## MEMORANDUM

Re: Geohydrologic Review

GZA GeoEnvironmental, Inc. (GZA) has completed a geohydrologic review at the 6 Manitou Court, Westport, Connecticut (Site). This memorandum was prepared to address one of the Connecticut Department of Energy and Environmental Protection (CTDEEP) comments in their May 29, 2020 letter (comment 2G). Specifically, we evaluated whether the upland groundwater seeps have the potential to cause slope failure that would impact the nearby seawall, and other proposed structures. Our services were conducted in accordance with our proposal dated June 18, 2020. This memorandum is subject to the Limitations provided in Appendix A.

Figure C-2

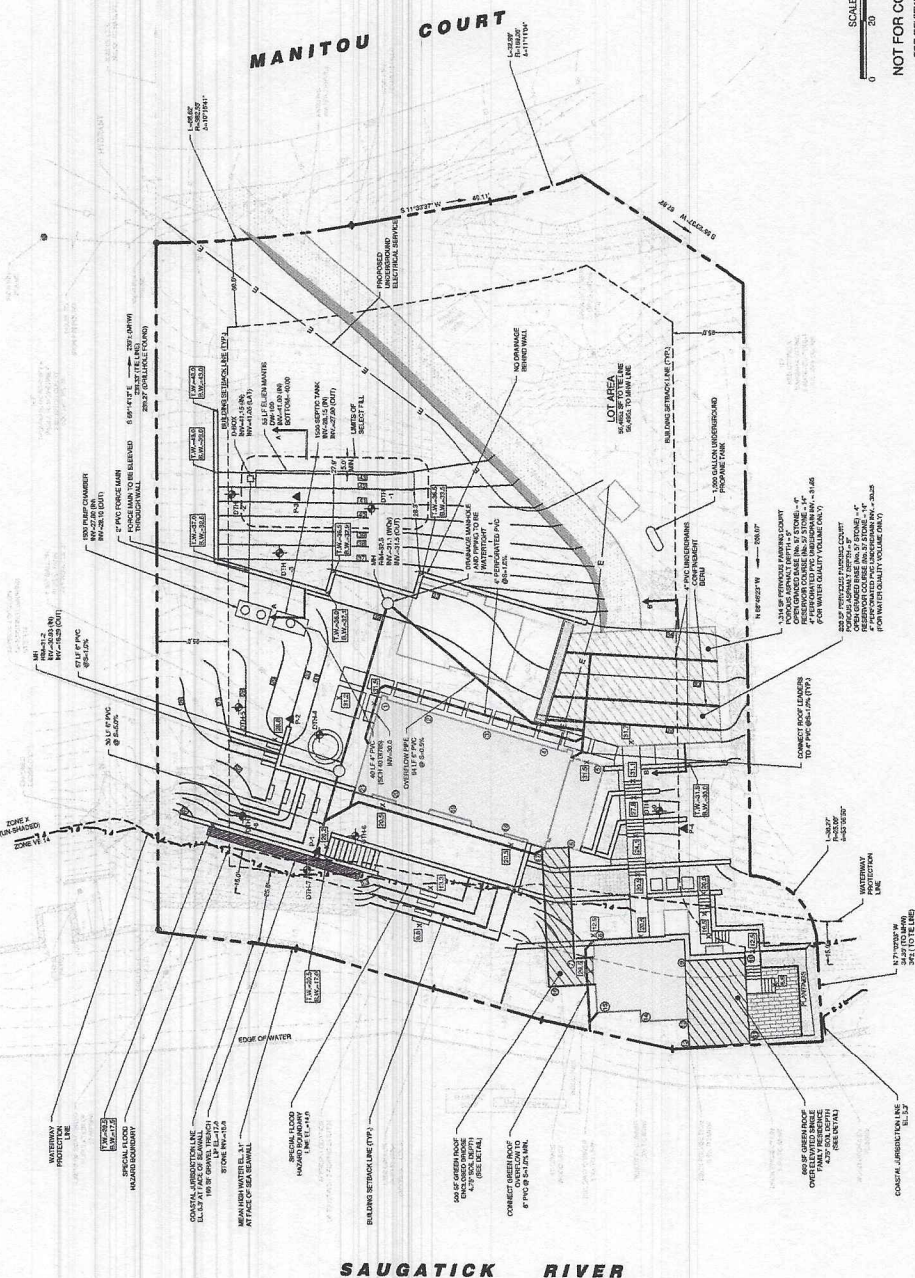
Some of the stormwater runoff will be directed to a 165 sf Gravel Trench located in the northwest portion of the Site. We understand the system is designed to infiltrate the design storm (i.e., 1-inch rainfall event) into the groundwater table. Larger design storms overflow the top of the Gravel Trench. The top of the Gravel Trench will be at elevation 17 feet and the bottom of the stone in the trench will be at elevation 15 feet. There is a 2 to 1 slope on the downgradient side of the Gravel Trench and at the base of the slope is a 1 to 2-foot-high stone retaining wall. A flat slope then extends 7 to 12 feet westward to the seawall. Refer to Figures 1 and C-2 for proposed conditions.

2. The area downgradient of the Gravel Trench (with 2 to 1 side slopes and a stone retaining wall at the base of the slope) should be designed to prevent surficial erosion or groundwater seeps. In addition, the southern portion of the Gravel Trench should be adjusted such that the top surface of the Gravel Trench (at elevation 17 feet) will be consistent with the proposed grades in that area, and will not cause seepage breakout at the abutting lawn steps (to the south).
